#### AGENDA

#### PLANNING & ZONING COMMISSION REGULAR MEETING TUESDAY, OCTOBER 5, 2021 - 3:30 PM MCALLEN CITY HALL, 1300 HOUSTON AVENUE CITY COMMISSION CHAMBERS, 3<sup>RD</sup> FLOOR

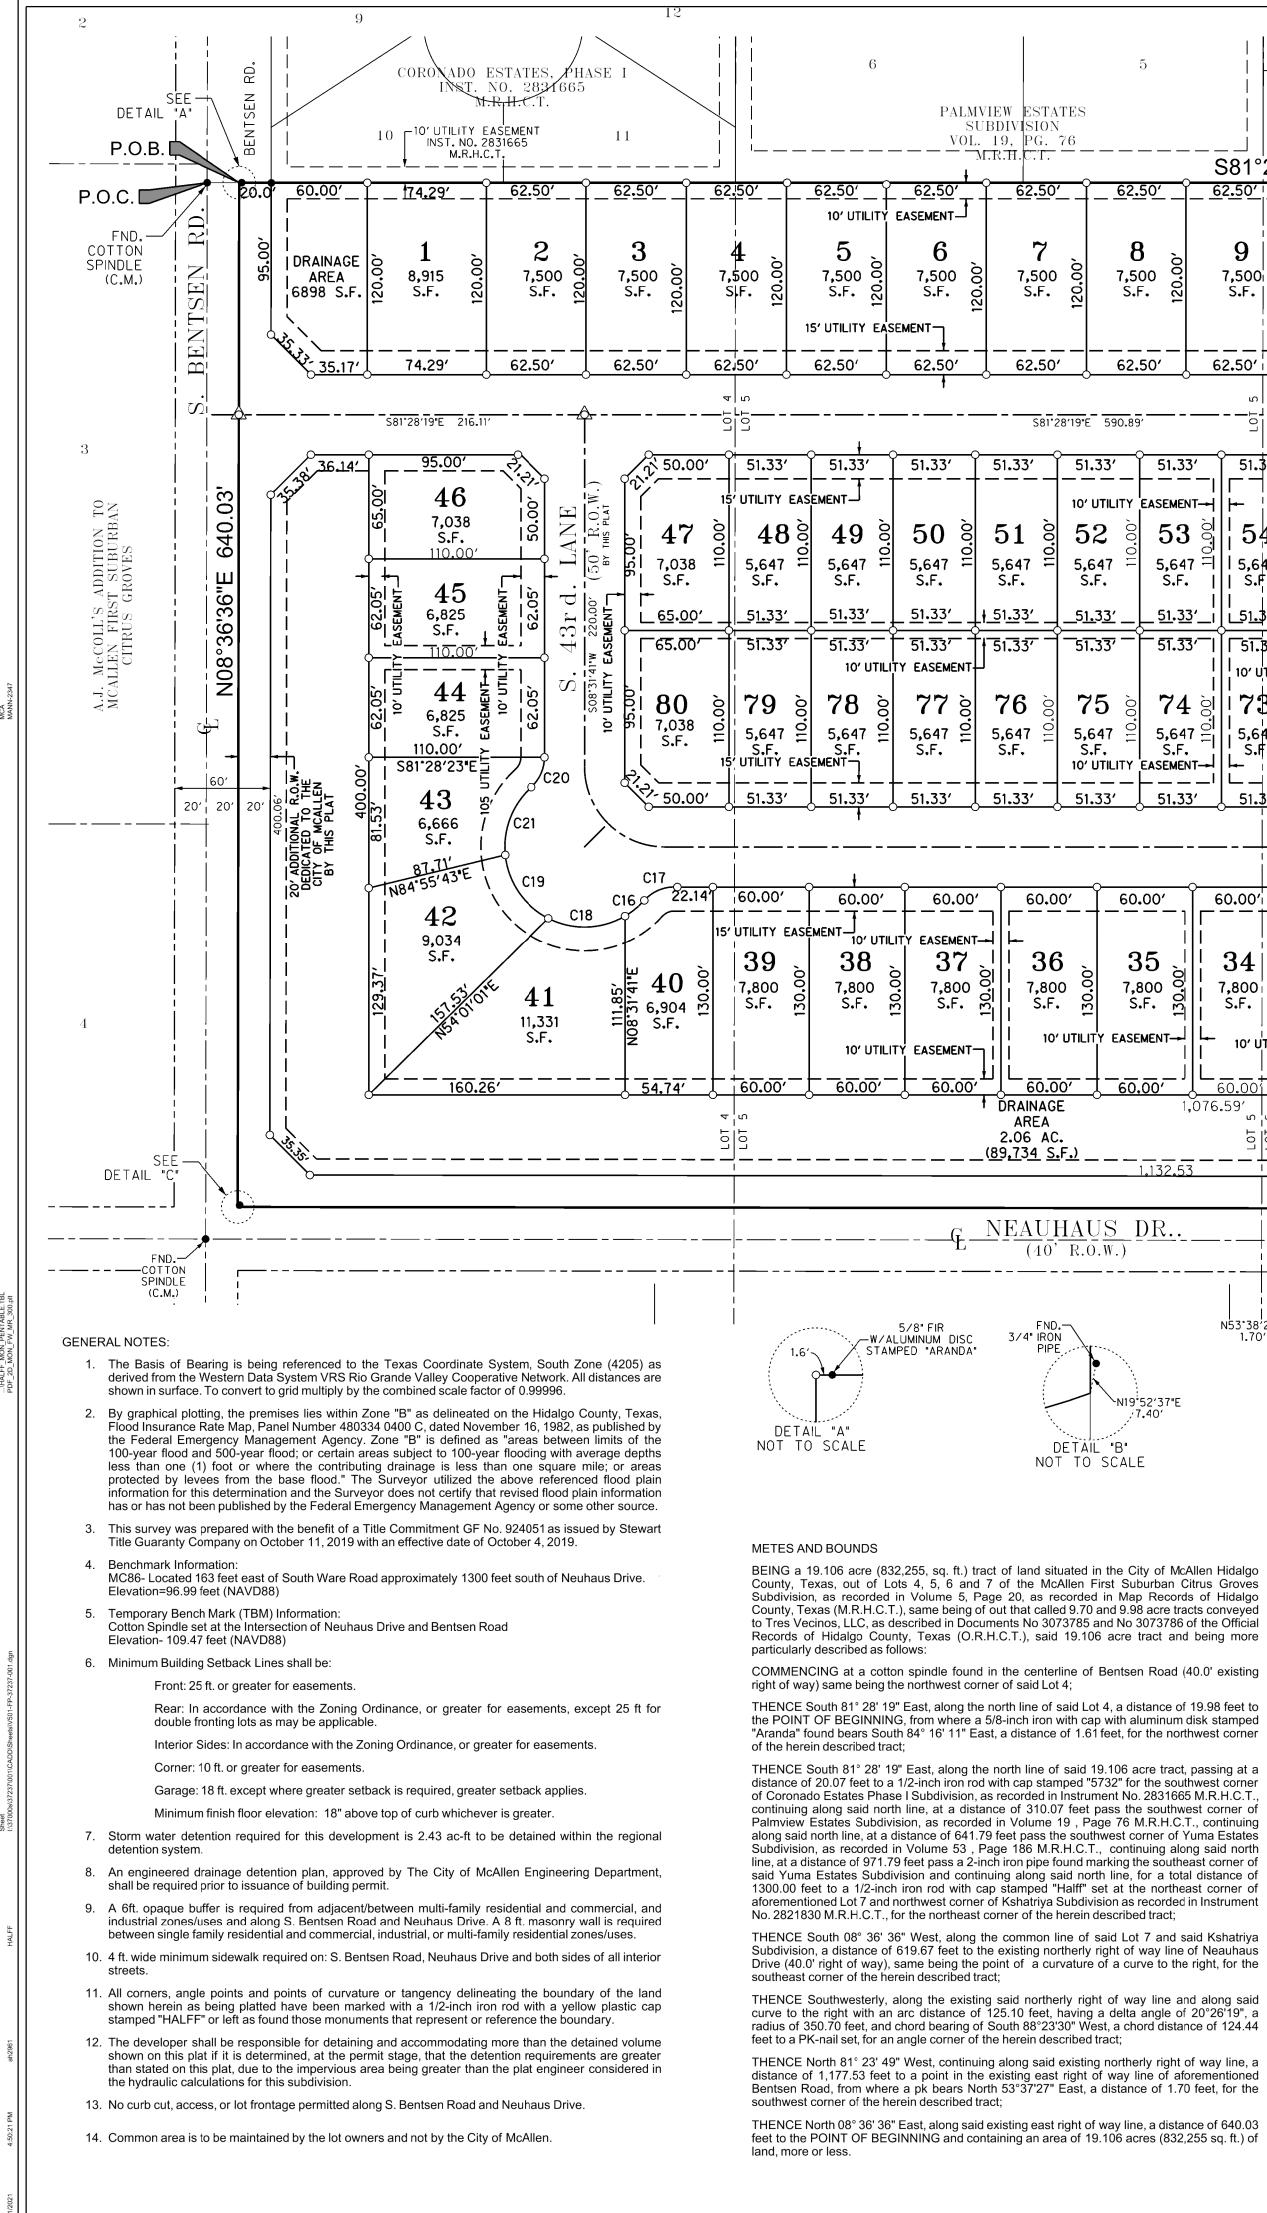
SUBDIVISION NAME: LOS VECINOS	
REQUIREMENTS	
STREETS AND RIGHT-OF-WAYS	
S. Bentsen Rd. 20 ft. ded. for 40 ft. from centerline for 80 ft. ROW Paving: 52 ft. Curb & gutter: Both sides **Must escrow monies if improvements are not built prior to recording.	Applied
Neuhaus Drive - 20 ft. dedication for 60 ft. ROW, and must match existing to east Paving: 40 ft. Curb & gutter: Both sides **Must escrow monies if improvements are not built prior to recording. ***Engineer submitted a variance letter on February 19, 2019, to not provide escrows for Neuhaus Dr. expansion and approved by City Commission with conditions.	Applied

* Interior Sides: In accordance with the Zoning Ordinance or greater for easements.	Applied
* Corner: 10 ft. or greater for easements.	Applied
* Garage: 18 ft. except where greater setback is required; greater setback applies.	Applied
*ALL SETBACKS ARE SUBJECT TO INCREASE FOR EASEMENTS OR APPROVED SITE PLAN	Applied
SIDEWALKS

* No curb cut, access, or lot frontage permitted along S. Bentsen Road and Neuhaus Drive	Compliance
* Site plan must be approved by the Planning and Development Departments prior to building permit issuance.	NA

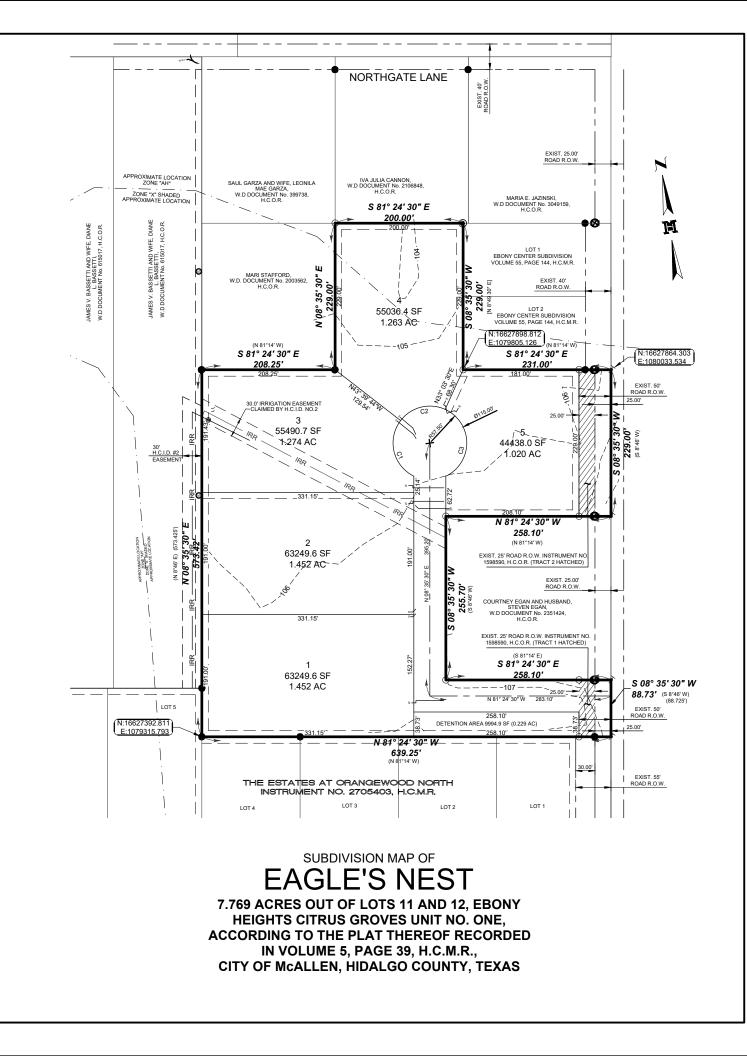
SUBDIVISION NAME: EAGLES NEST SUBDIVISION	
REQUIREMENTS	
STREETS AND RIGHT-OF-WAYS	
N. 2nd Street (N. Col Rowe Blvd.): 60 ft. ROW required from centerline for 120 ft. total ROW Paving: min. 65 ft. Curb & gutter: both sides *Revise street name as shown above **Revise plat to show required dedication for N. 2nd Street (Col. Rowe Blvd.) ***Remove shading pattern from existing ROW shown on plat under document number 1598590	Non-compliance
Paving Curb & gutter	Applied
Interior streets: 50 ft. ROW Paving: 32 ft. Curb & gutter: both sides **Revise plat to show interior streets' width ***City of McAllen Thoroughfare Plan	Non-compliance

* Front: 25 ft. or greater for easements, whichever is greater *Zoning Ordinance: Section 138-356	Applied
* Rear: 10 ft., except 25 ft. for Lot 5 *Revise plat as noted above **Zoning Ordinance: Section 138-356	Non-compliance

* Interior sides: 6 ft. or greater for easements, whichever is greater *Revise plat as noted above **Zoning Ordinance: Section 138-356	Non-compliance
* Side corner: 10 ft. or greater for easements whichever is greater **Zoning Ordinance: Section 138-356	Applied

* Garage: 18 ft. except where a greater setback is required, greater setback applies. *Zoning Ordinance: Section 138-356	Applied
*ALL SETBACKS ARE SUBJECT TO INCREASE FOR EASEMENTS OR APPROVED SITE PLAN	Applied
SIDEWALKS	
<ul> <li>* 4 ft. wide minimum sidewalk required on the west side of N. 2nd Street (Col. Rowe Blvd.) and both sides of interior streets.</li> <li>*Revise plat as noted above</li> <li>**Subdivision Ordinance: Section 134-120</li> </ul>	Non-compliance

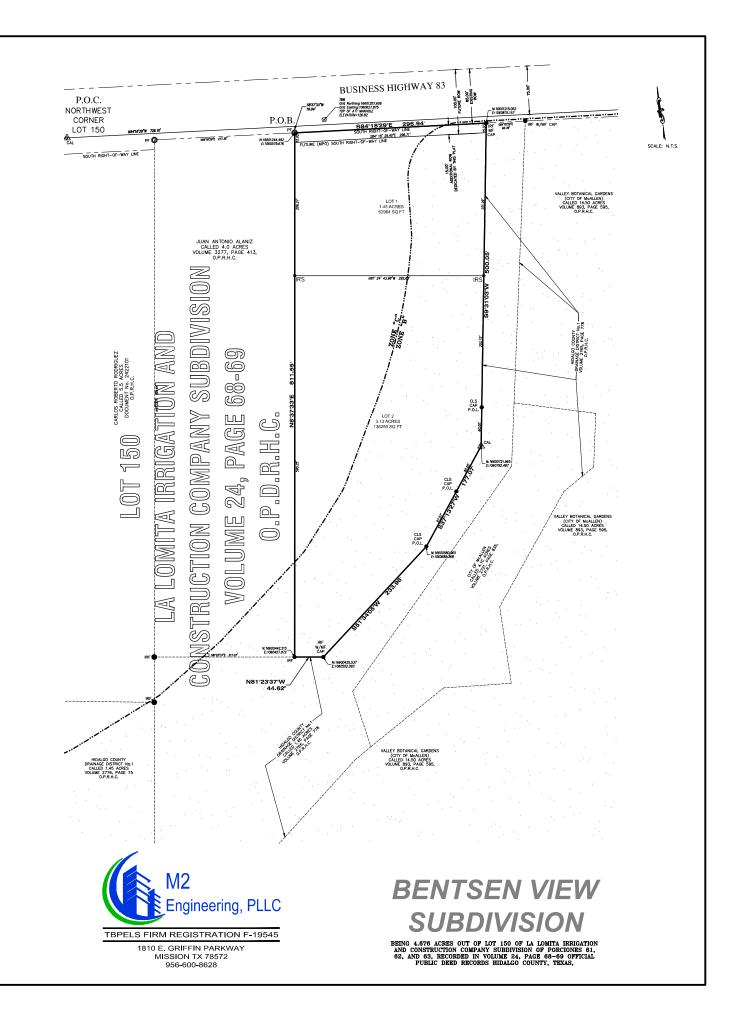
Reviewed On: 9/28/2021	
SUBDIVISION NAME: BENTSEN VIEW SUBDIVISION	
REQUIREMENTS	
STREETS AND RIGHT-OF-WAYS	
U.S. Business Highway 83 (Loop 374): 50 ft. ROW required from centerline for 100 ft. total ROW Paving: by the state Curb & gutter: by the state *Show centerline and label existing ROW on both sides	Non-compliance
Interior street(s): 60 ft. Paving: 40 ft. Curb & gutter: both sides *Revise plat and label interior ROW **City of McAllen Thoroughfare Plan	Non-compliance
Paving Curb & gutter	Applied
Paving Curb & gutter	Applied
Paving Curb & gutter	Applied
<ul> <li>* 800 ft. Block Length</li> <li>*Revise layout to determine whether a variance request will be needed i.e. will there be interior streets? Lot 2 has no frontage.</li> <li>**Subdivision Ordinance: Section 134-118</li> </ul>	Non-compliance

* 600 ft. Maximum Cul-de-Sac *Proposed layout needs to be revised since Lot is currently landlocked. **Subdivision Ordinance: Section 134-105	Non-compliance
ALLEYS	
ROW: 20 ft. Paving: 16 ft. *Alley/service drive easement required for commercial properties **Subdivision Ordinance: Section 134-106	Non-compliance
SETBACKS

* Front: Proposing 50 ft. or greater for easements or approved site plan. **Revise as noted above. ***Zoning Ordinance: Section 138-356	Non-compliance
* Rear: 15 ft. or greater, for approved site plan or easement, whichever is greater *Zoning Ordinance: Sec.138-356	Applied
<ul> <li>* Interior Sides: In accordance with the zoning ordinance or greater for easements, or approved site plan</li> <li>*Revise plat as noted above</li> <li>**Zoning Ordinance: Sec.138-356</li> </ul>	Non-compliance

* Corner **Zoning Ordinance: Section 138-356	NA
* Garage: Proposing 18 ft. except where greater setback is required, greater setback applies *Application indicates proposed use is commercial, pending clarification whether or not garages are proposed **Zoning Ordinance: Section 138-356	TBD
*ALL SETBACKS ARE SUBJECT TO INCREASE FOR EASEMENTS OR APPROVED SITE PLAN	Applied

* Trip Generation needed per Traffic Department to determine if TIA is required, prior to final plat.	Non-compliance
